UNITED STATES PATENT AND TRADEMARK OFFICE

APPLICATION NO.	FILING DATE	FIRST NAMED INVENTOR	ATTORNEY DOCKET NO.	CONFIRMATION NO.
10/735,664	12/16/2003	Vladimir M. Kabakov		2852

Office Action Summary	Application No.	Applicant(s)	
	10/735,664	KABAKOV, VLADIMIR M.	
	Examiner	Art Unit	
	Sherman D. Basinger	3617

DETAILED ACTION

Fig. 4.

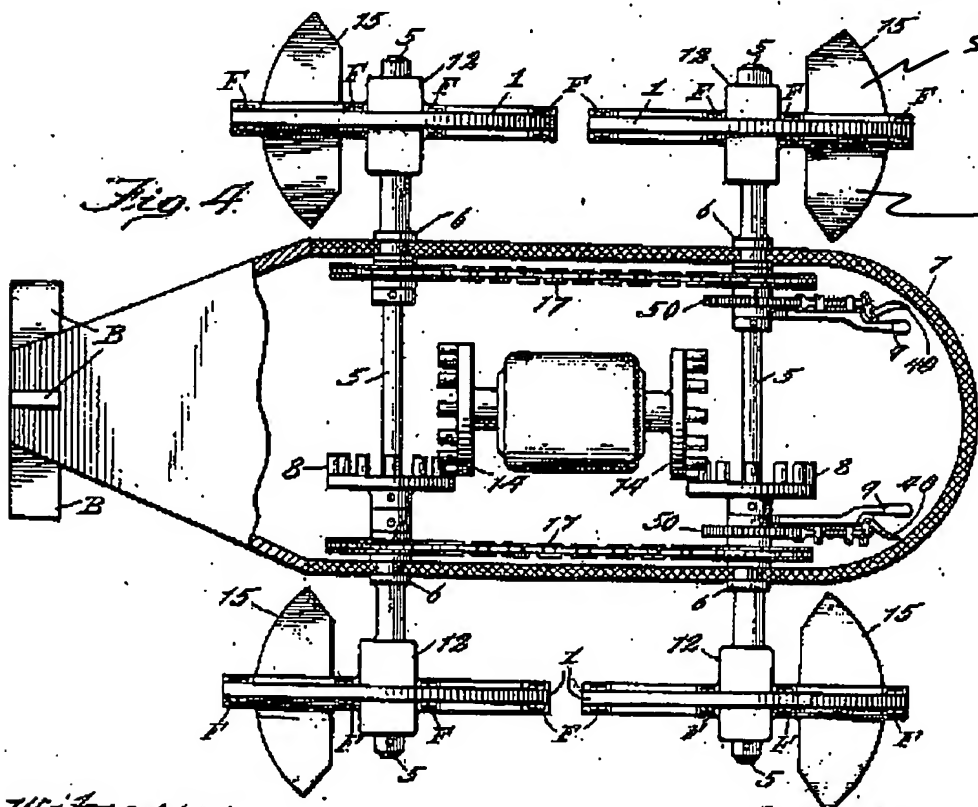
axes (note the attached copy of figure 4 of Roney which has been marked to show what is considered to be the flat propeller blade and what is considered to be balance or counterweight for the blade so as to balance the blade on the axes 2,2.

substantially
flat propeller
blade

balances
propeller
blade
(counter
weight)
